PROPOSED SITE PLAN
PORTSMOUTH MAPLE MASJID
686 MAPLEWOOD AVENUE
PORTSMOUTH, NEW HAMPSHIRE
PERMIT PLAN

PLAN SET SUBMITTAL DATE: 19 FEBRUARY 2019

LANDSCAPE PLAN

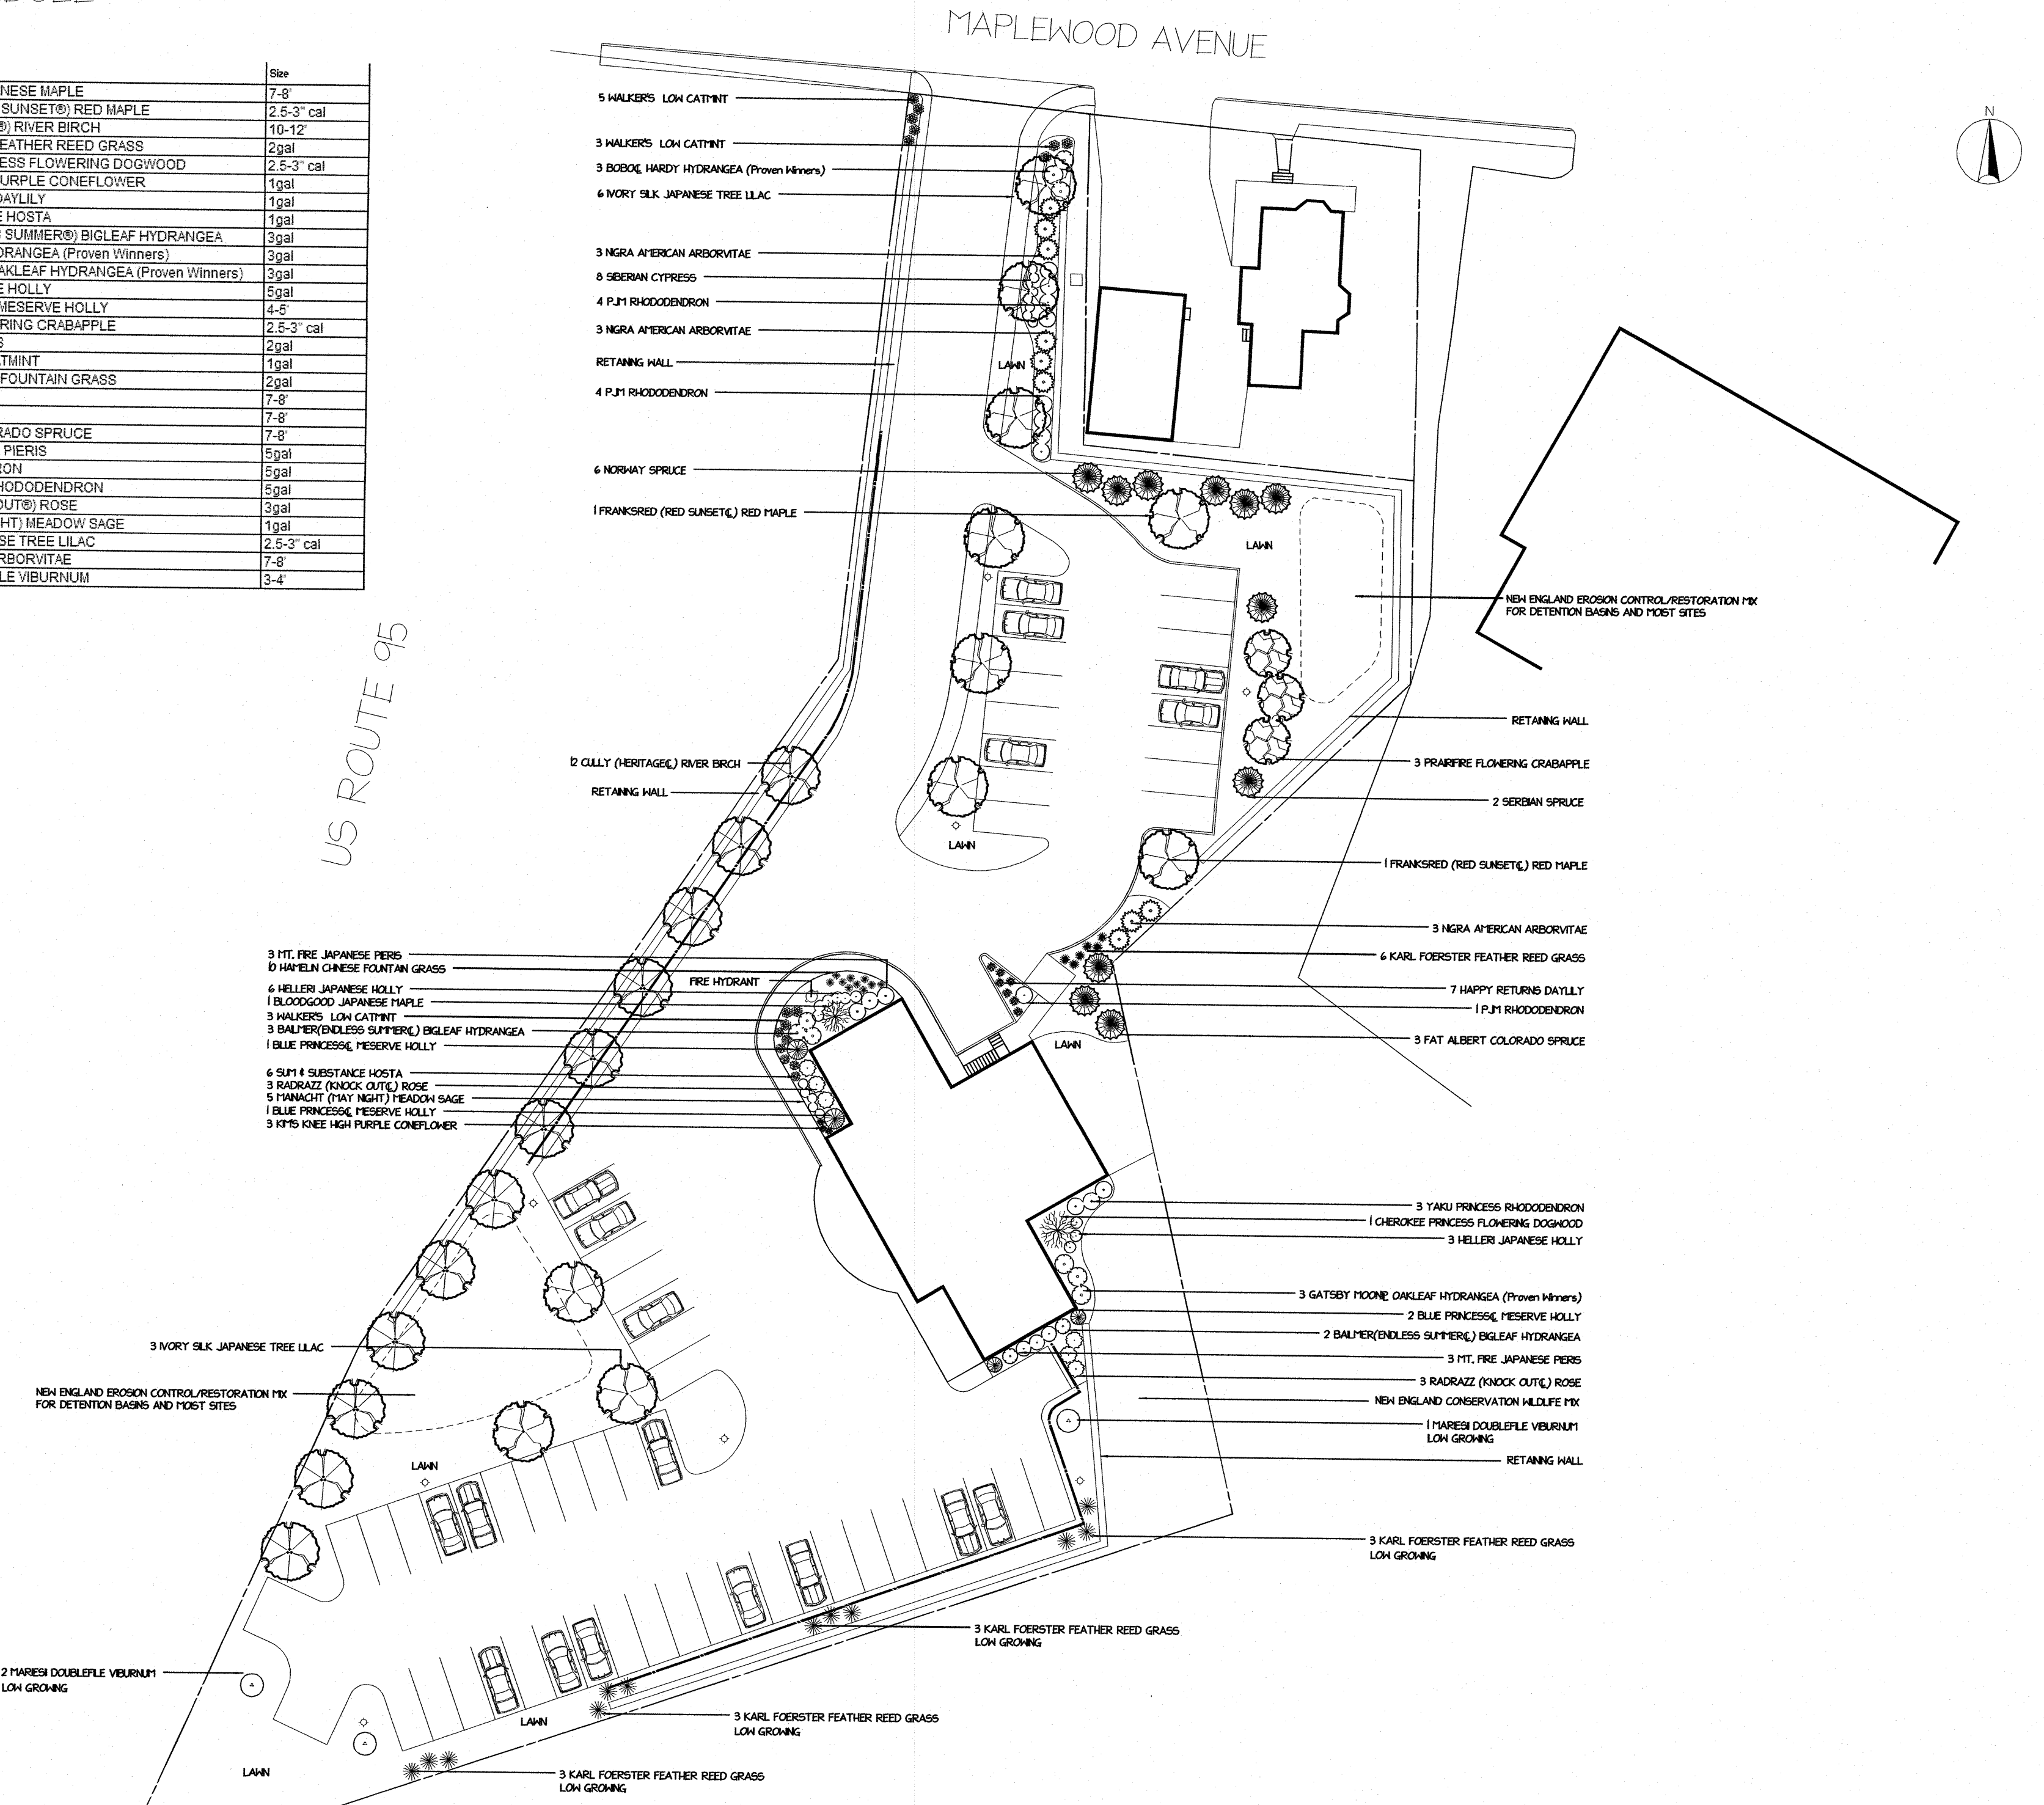
2. Landscape plan must be modified to eliminate any blockage of Fire Department Connection or hydrant on north side of building. The yard hydrant seems very close to the building, please review with Fire Department **We have removed any plantings within 5' of the Hydrant. Please see sheet L1.**

HH
C4 WALL SECTION & FILTRATION BASIN PS1a

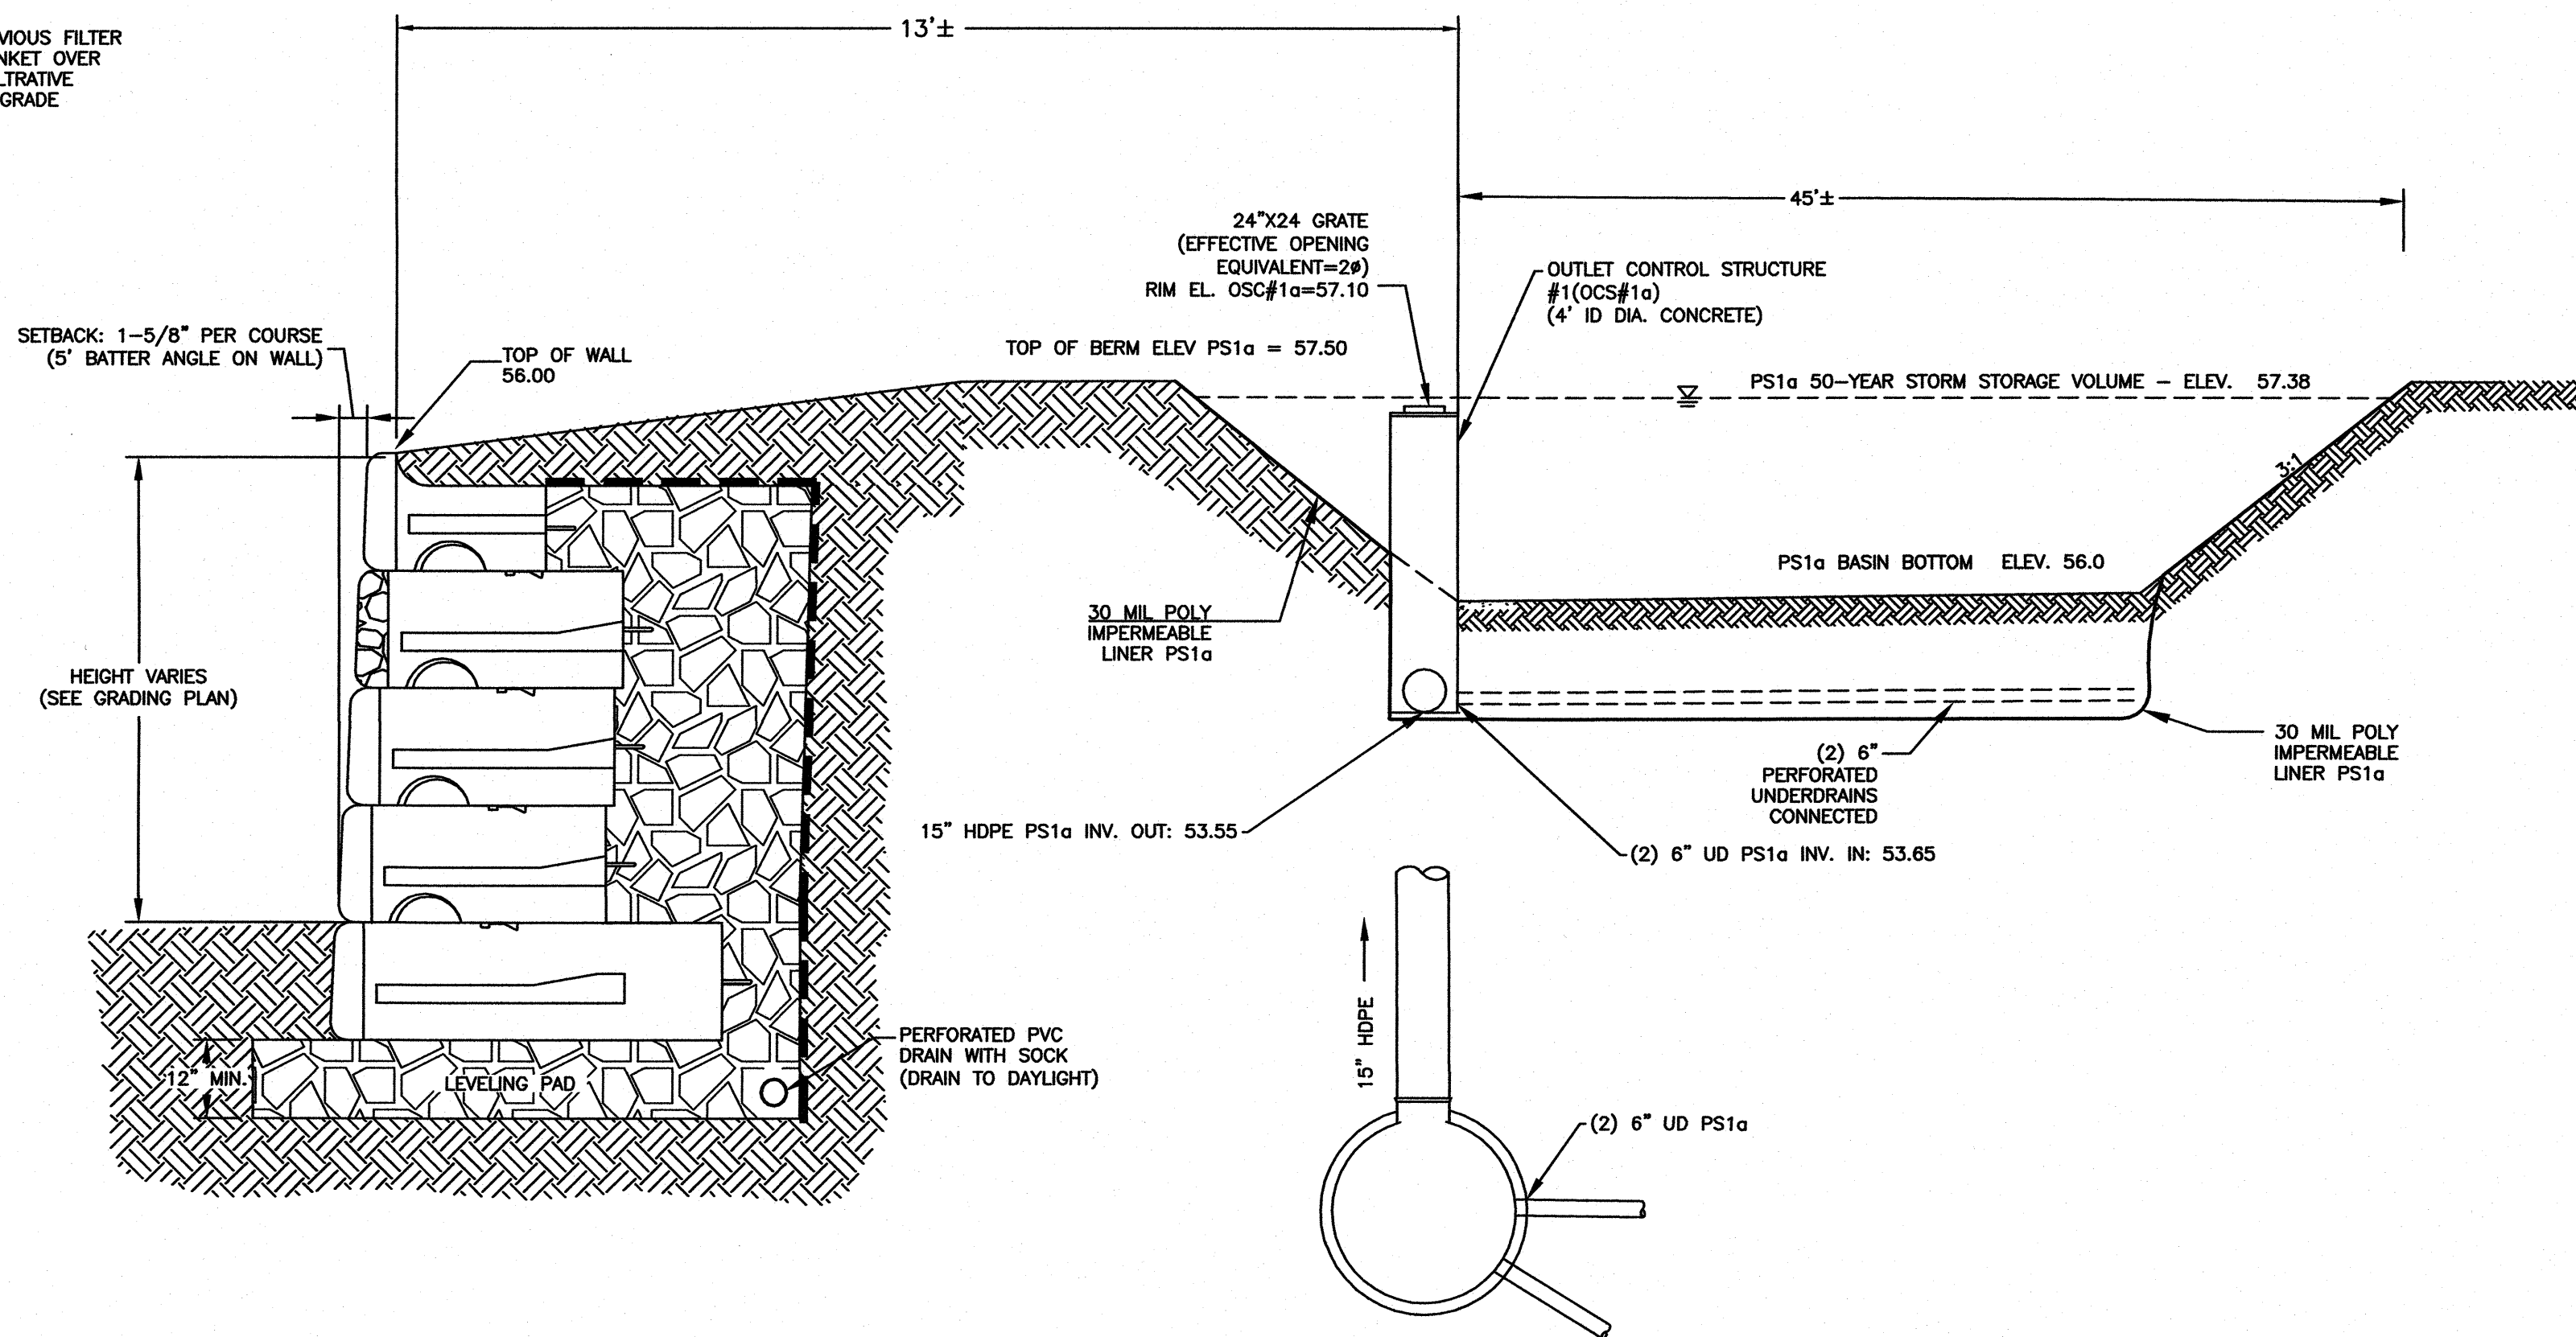
4. Detail D on sheet D1 is inadequate. The intent is to show how the stormwater pond will be constructed to prevent ponded water from leaking down and blowing out the wall. **Detail HH on sheet D& has been added showing a 30 Mil impermeable liner that removes water from the area before it gets to the wall.**
